## **BERNOUDY TRACT SUBDIVISION, SQUARE 186, LOTS 6 & 7**

Engineering Comments: FINAL PLAT COMMENTS (should be addressed prior to submitting the FINAL PLAT for review and/or signature by the City Engineer):

APPLICATION NUMBER 2 DATE September 19, 2019

REQUEST Subdivision

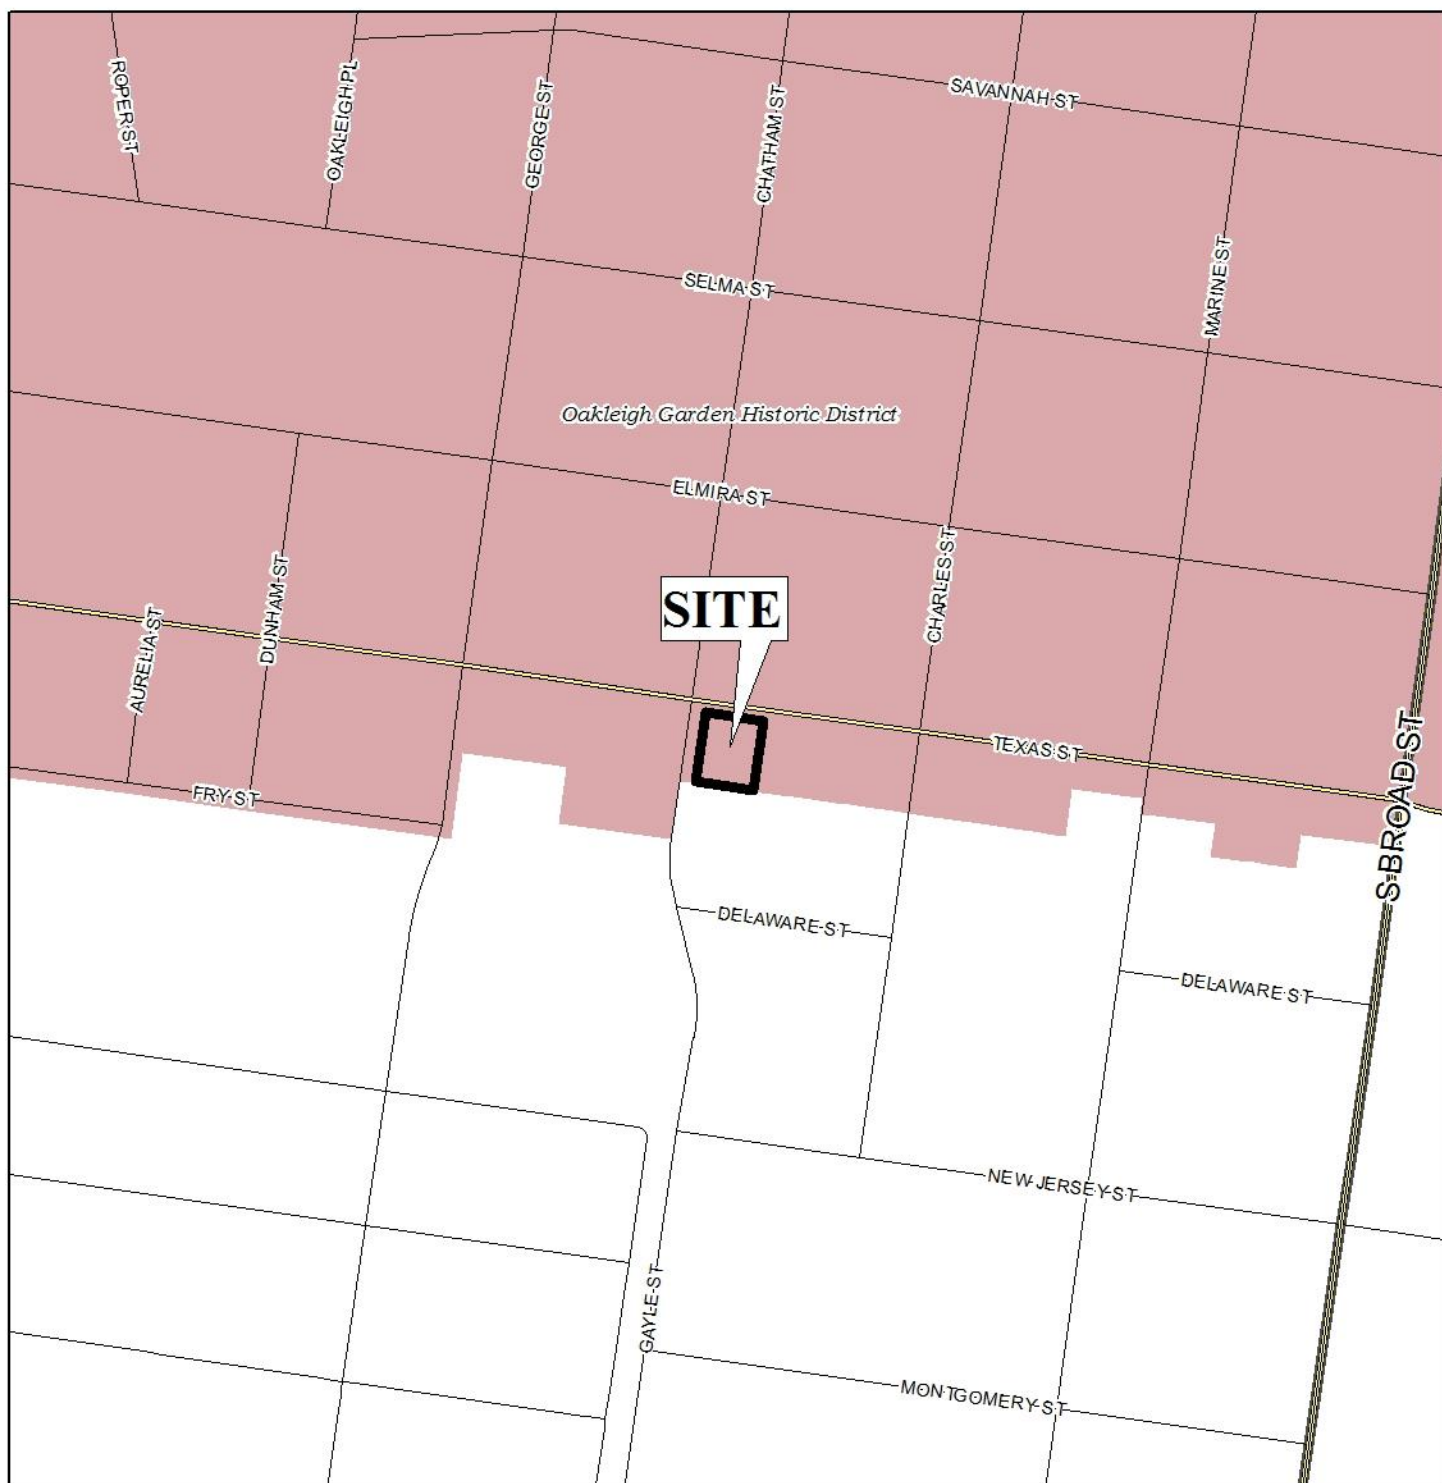
- B. Provide and label the monument set or found at each subdivision corner.
- C. Dedicate the corner radius (25' minimum or as approved by the City Engineer and Traffic Engineer) at the northwest corner LOT 7.

Both proposed lots front Texas Street, and proposed lot seven (7) also fronts Chatham Street. Both streets are minor streets with compliant 50-foot rights-of-way; therefore no frontage dedication would be required. Pertaining to the applicant's request to waive a corner radius dedication at the intersection of Texas Street and Chatham Street, the Subdivision Regulations in Section V.B.16 require a minimum radius of 20-feet, and City Engineering comment B stipulates a corner radius of 25-feet.

The lot size labels in both square feet and acres should be retained on the Final Plat, adjusted for any required radius dedication, or a table should be furnished on the Final Plat providing the same information.

As a means of access management, a note containing the Traffic Engineering comments should be placed on the Final Plat.

- 1) Dedication of a 25-foot corner radius as required by Section V.B.16 of the Subdivision Regulations and Comment C of the Engineering Comments;

- 3) retention of the lot size labels in both square feet and acres on the Final Plat, adjusted for any required radius dedication, or the furnishing of a table on the Final Plat providing the same information;

- 5) placement of a note on the Final Plat stating the Traffic Engineering comments: *(Driveway number, size, location and design to be approved by Traffic Engineering and conform to AASHTO standards.);*
